Wollongong Local Planning Panel Assessment Report | 3 December 2021

WLPP No.	Addendum Report to WLPP Item 2- 22 June 2021
DA No.	DA-2021/69
Proposal	Residential - construction of multi-unit housing and Subdivision - Strata title - 17 lots
Property	Lot 15 DP 24874, Lot 25 DP 237812 2-8 Highway Avenue, West Wollongong
Applicant	Kollaras Developments Pty Ltd
Responsible Team	Development Assessment & Certification – City Centre Team (VD)
Prior WLPP meeting	22 June 2021

ADDENDUM REPORT

Figure 2- Original submitted design

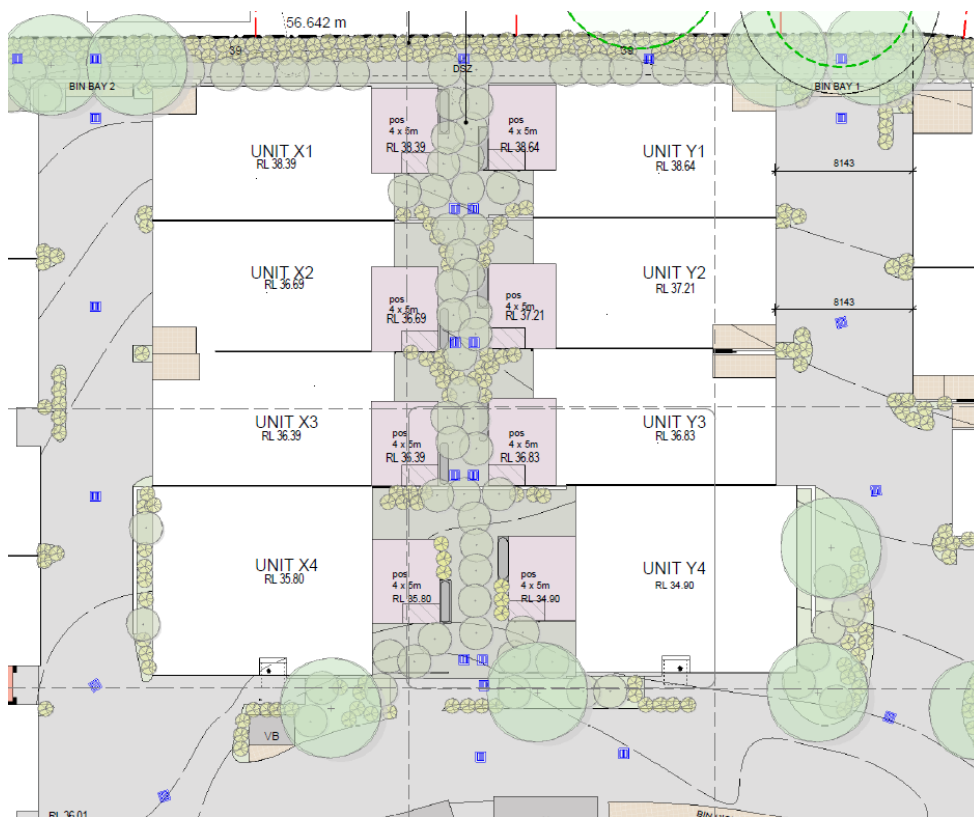
- ***redesign units X1 to X4 and Y1 to Y4 to achieve:***
 - ***a reduction to 6 units resulting in a reduced building footprint in the unit block centrally location within the site;***
 - ***additional landscape area on the southern edge of the central unit block (adjacent to the entry driveway) and at the northern end of each driveway;***
 - ***provide for improved amenity and an increased size of the rear yards of central block units with improved landscaping which provides for a high level of privacy and amenity; and***
 - ***a revised landscape strategy that addresses significant use of local species, their size and location in rear yards.***

The application retains the original number of units (17 units) and a reduction to 6 units has not been carried out. Changes have been made to the overall design including the following:

- Unit Z1 repositioned to have the POS on the north side which resulted in minor modifications to the ground and first floor layouts. This unit has also moved the east.
- Unit Z2 living and kitchen area has been reduced by 500mm and move to the east.
- Setbacks for Z1, Z2, Z3 reduced slightly but maintain compliance with DCP provisions.
- Units Y1-Y3 living and kitchen area reduced by 500mm and move to the east.
- Unit X1-X3 living and kitchen area reduced by 500mm.
- Separation between units X1 to X4 and Y1 to Y4 has been increased by approximately 3m, achieving a minimum separation of over 11m apart at their closest point. Previously 8.250m separation between these units.
- Details of fencing between units provided.
- Additional screen planting and landscaping has been provided in the rear courtyards to further enhance privacy screening and amenity for future residents.

The amended proposal responds to the concerns raised by the WLPP by design rather than a reduction of units. The development is below the permissible FSR for the site and within the prescribed height limits. The total amount of landscaping exceeds the minimum requirements of 30% for the site. The application is supported from Council's Traffic, Stormwater and Landscape Department. Modifications to landscaping and privacy have improved the overall design concept.

privacy screen

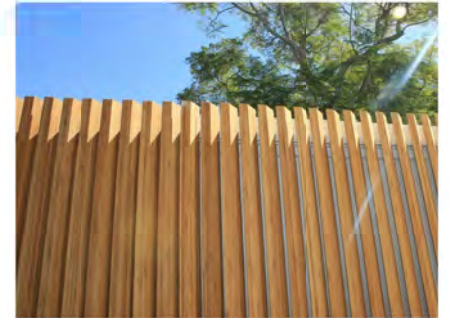
- ***detail privacy mitigation measures between units;***

Details of new fencing between courtyard areas for the units has been provided. Fencing will be 1.8m high timber fencing as detailed in the landscape plans and shown below. A privacy screen as also been included on the southern side of the deck to Unit W2.
